Department of Planning, Housing and Infrastructure

**RE: SES Correspondence to DPHI (29 Jan 2024) regarding
Mirvac Georges Cove Marina Planning Proposal, 146 Newbridge Rd, Moorebank**

ATTACHMENT C
SES Letter in response to the Mirvac PP
29 January 2024

Planning Proposal for 146 Newbridge Road, Moorebank

Figure 2 Rates of Rise in floodwaters downstream of Newbridge Road

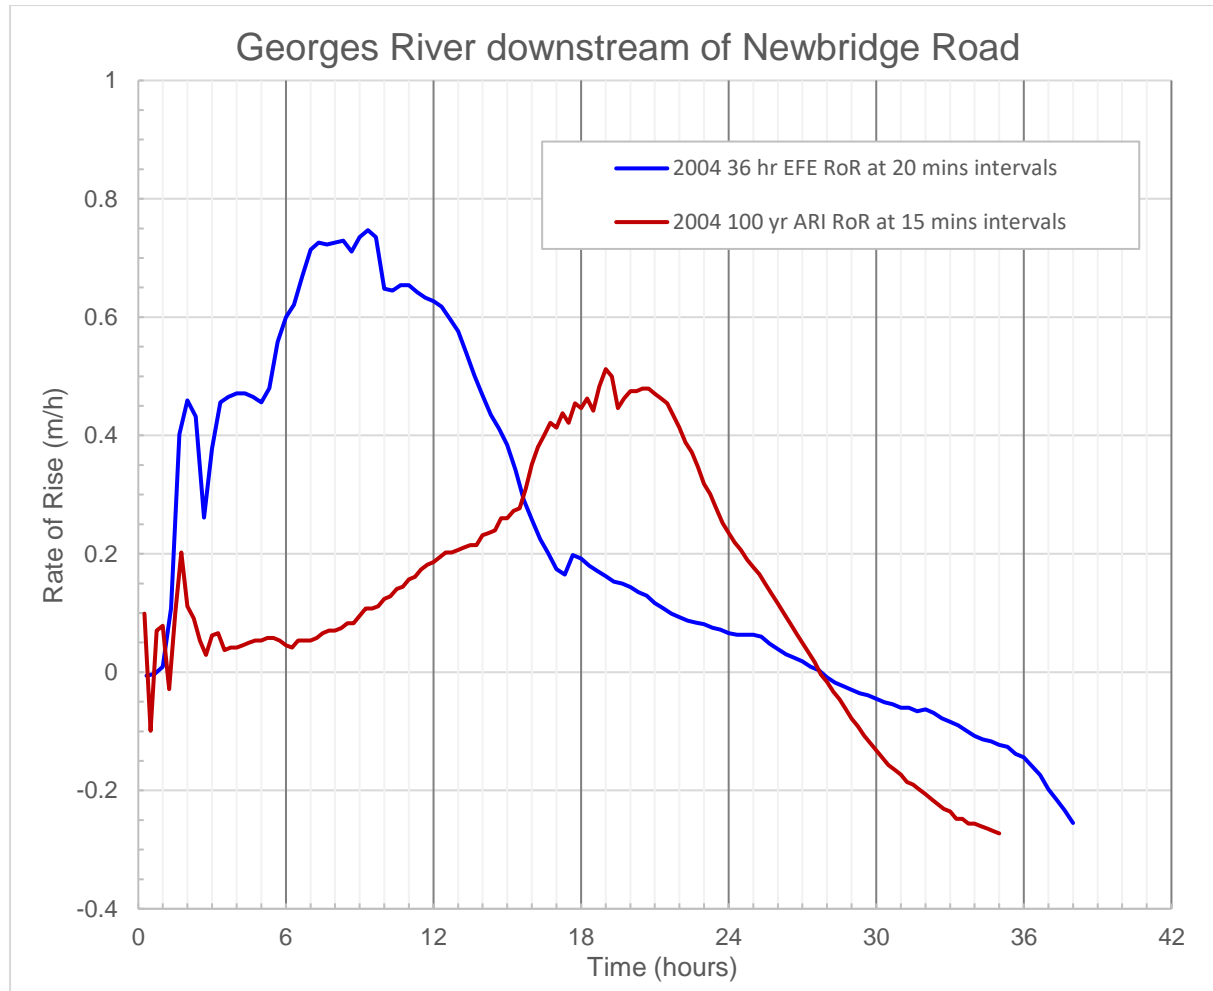
This is not correct. A comparison of the rate of rise of the 36 hour Extreme Flood Event (EFE) and 100 yr ARI flood is given in Figure 2 on the next page. This indicates that more frequent events are not as likely to rise at the rate of the EFE. There is a stark difference in the rate of rise for the 100 year ARI flood which takes 16 hours to achieve any similar rate of rise as for the PMF type flood as demonstrated in Figure 2 below. This would provide a significantly longer flood warning time and greatly increased capacity for evacuating vehicles from the area.
